CEMCO TRANSMISSIONS SITE PLAN #90-22
ST. ANNE DR. (DASCOLI)

TOWN OF NEW WINDSOR
PLANNING BOARD
REVIEW COMMENTS

PROJECT NAME: CEMCO TRANSMISSION SITE PLAN
PROJECT LOCATION: NYS ROUTE 94 AND ST. ANN DRIVE
PROJECT NUMBER: 90-22
DATE: 12 JUNE 1991
DESCRIPTION: THE APPLICANT HAS SUBMITTED A PLAN FOR THE EXPANSION OF THE EXISTING THREE-BAY TRANSMISSION SHOP TO INCLUDE TWO (2) ADDITIONAL BAYS FOR A "LUBE/OIL" SERVICE. THE PLAN WAS PREVIOUSLY REVIEWED AT THE 9 MAY 1990, 13 JUNE 1990, 24 OCTOBER 1990, 13 FEBRUARY 1991, 13 MARCH 1991 AND 10 APRIL 1991 PLANNING BOARD MEETINGS.

SITE PLAN
 MARCH 6, 1990
 JULY 7, 1990
 JULY 24, 1990
 JULY 24, 1990
 JULY 24, 1990
 JULY 24, 1990

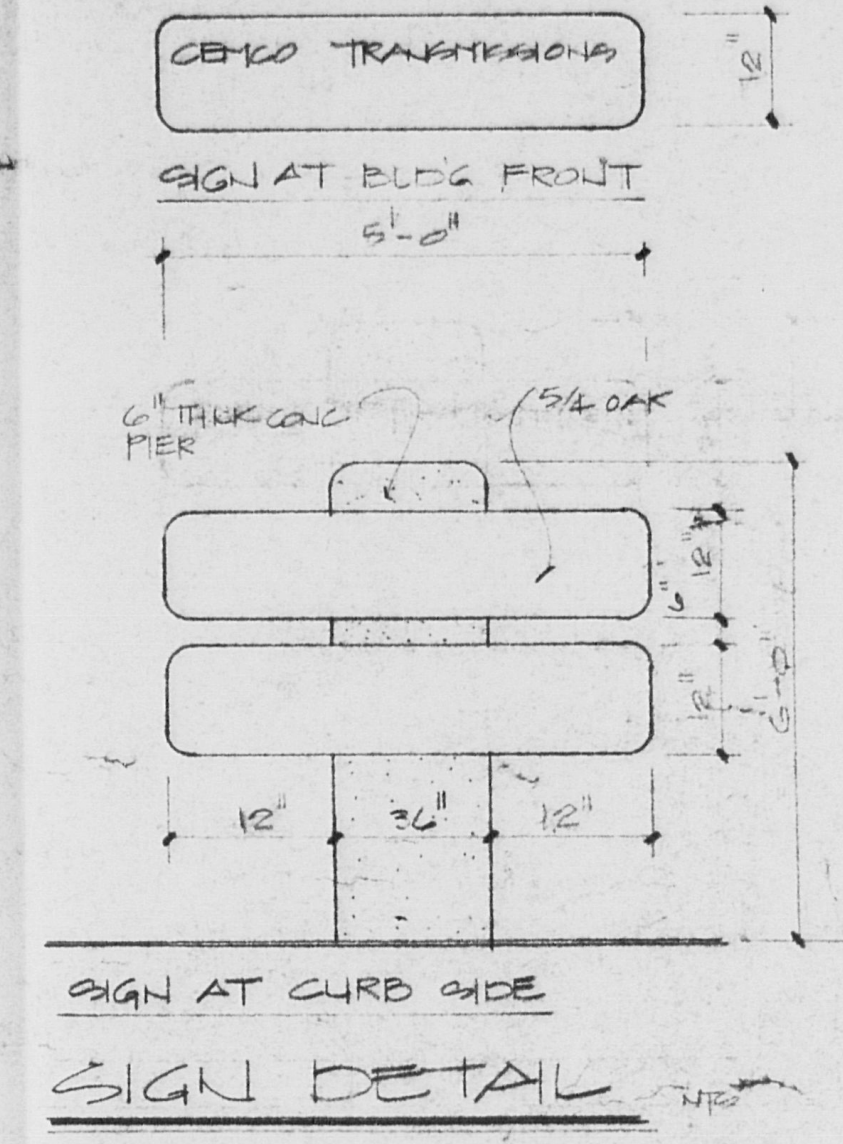
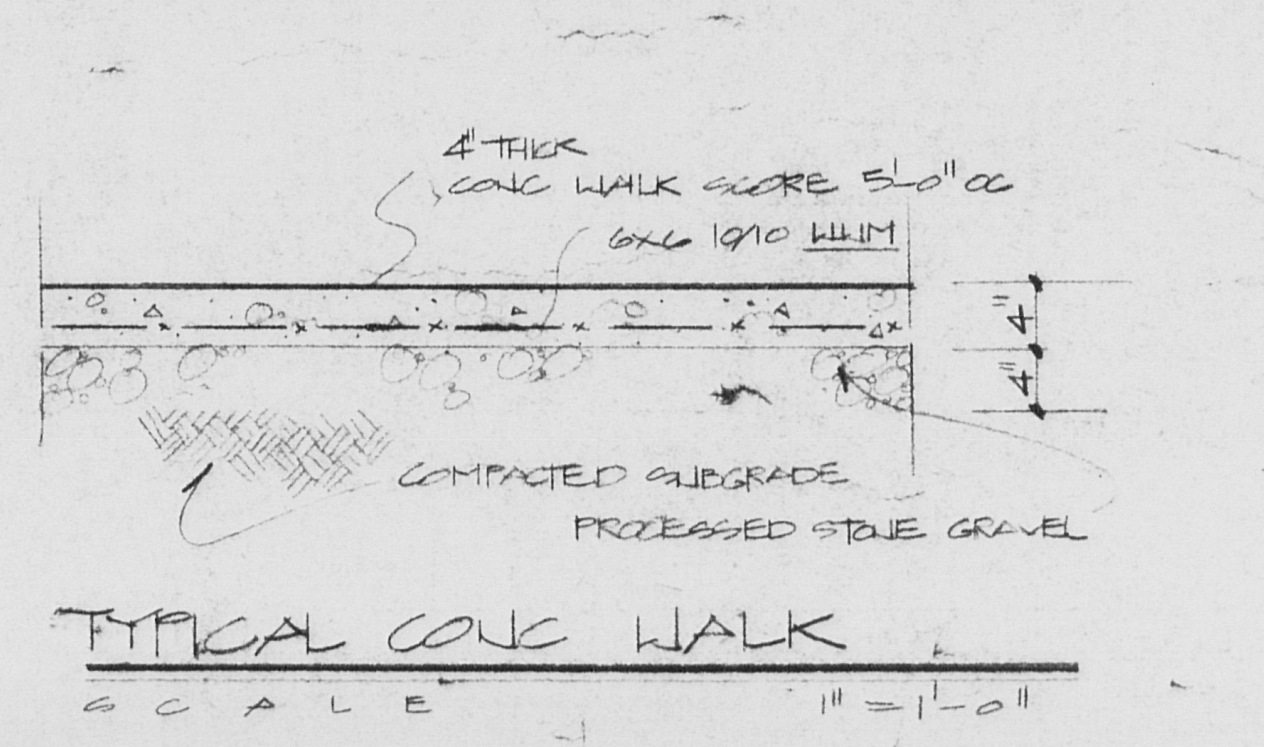
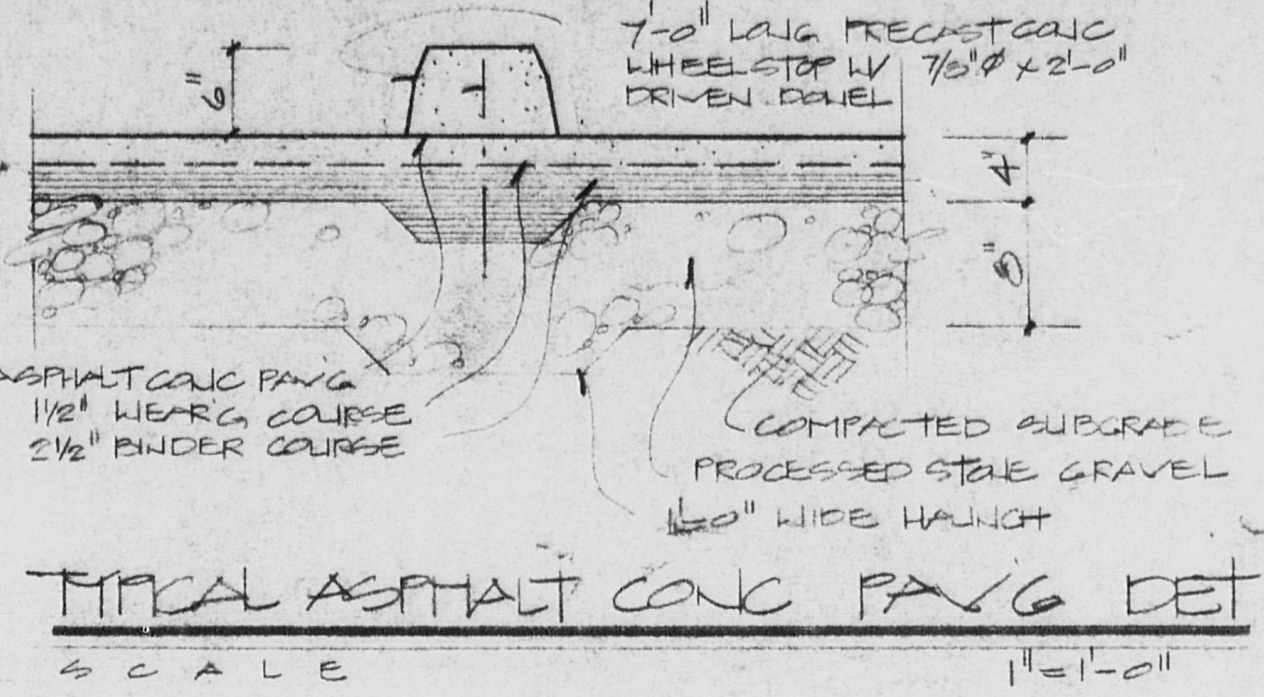
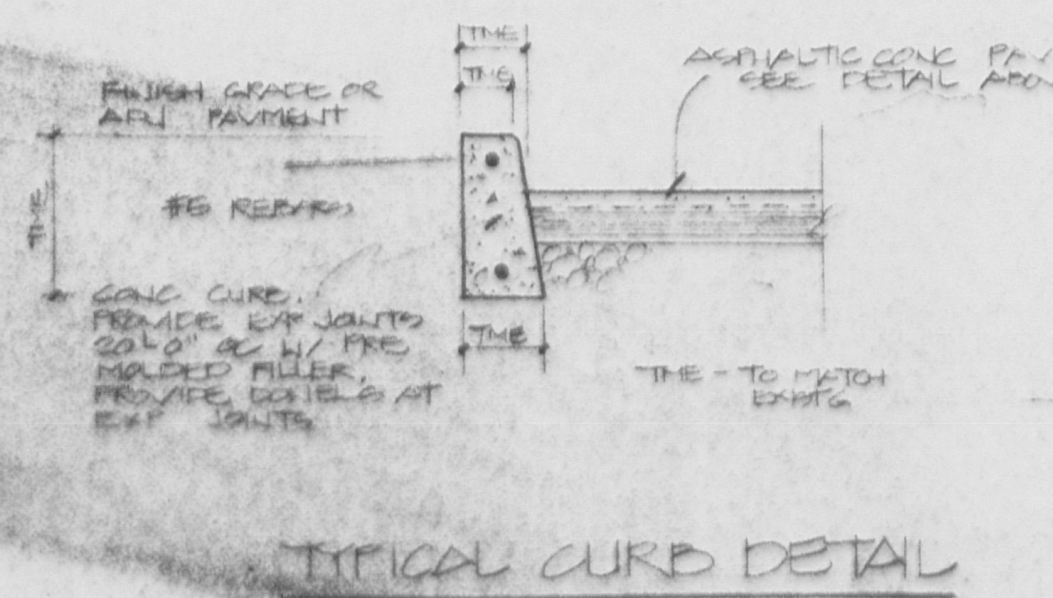
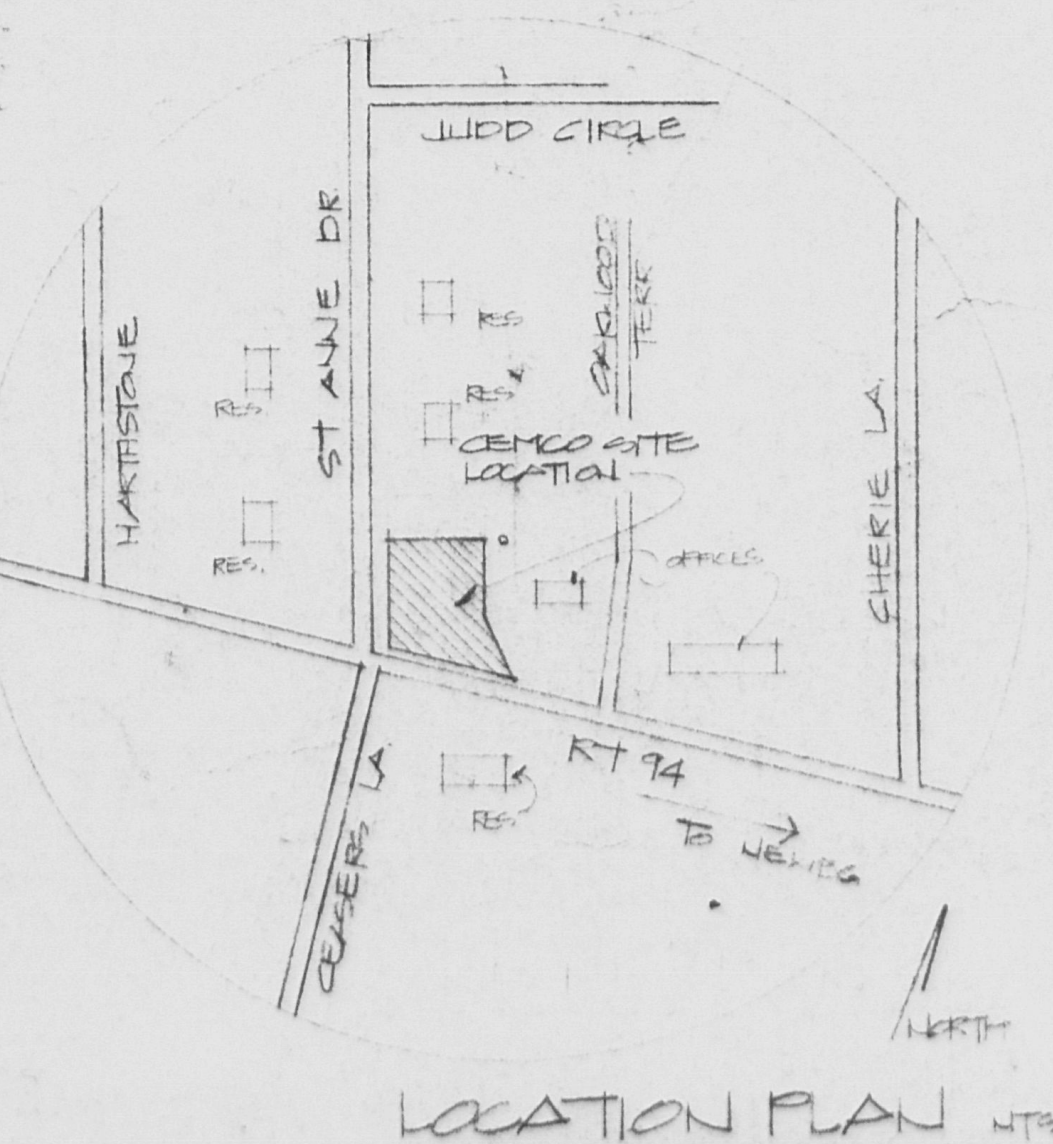
With regard to the lighting plan, the Applicant has submitted a manufacturer's design plan indicating levels of lighting throughout the site, utilizing the three (3) pole mounted lights and four (4) wall mounted units. This appears to be the best information we will receive; therefore, if acceptable to the Board, this lighting arrangement could be accepted. I do recommend that the Board consider requiring that the wall mounted units be required to be timer operated, based on business hours.

With regard to the relocation of the dumpster to the rear of the building, per the Technical Work Session of 30 April 1991, the Fire Inspector's office has advised that, per Section 1191.3(a)(4) of the State Building and Fire Code, dumpsters cannot be located at the building wall.

The bulk table on the plan continues to be incorrect and, as such, can not be used for referral to the ZBA. Please note the following:

- 1) The property is a corner lot and, therefore, has two front yards. The "proposed" portion of the table should reflect this, especially since they need a variance for front yard setback from St. Anne Drive. (Note that the plan shows a 25' setback, however this is not referenced in the table).
- 2) The "required - Total Both Sides" should be N/A, only one side yard exists.
- 3) As per our previous request, the provided side yard setback (13') should be noted as an existing non-conformance.
- 4) The applicant should verify that they want to construct the addition with a maximum height of 35'. If so, they may need a variance for this also.
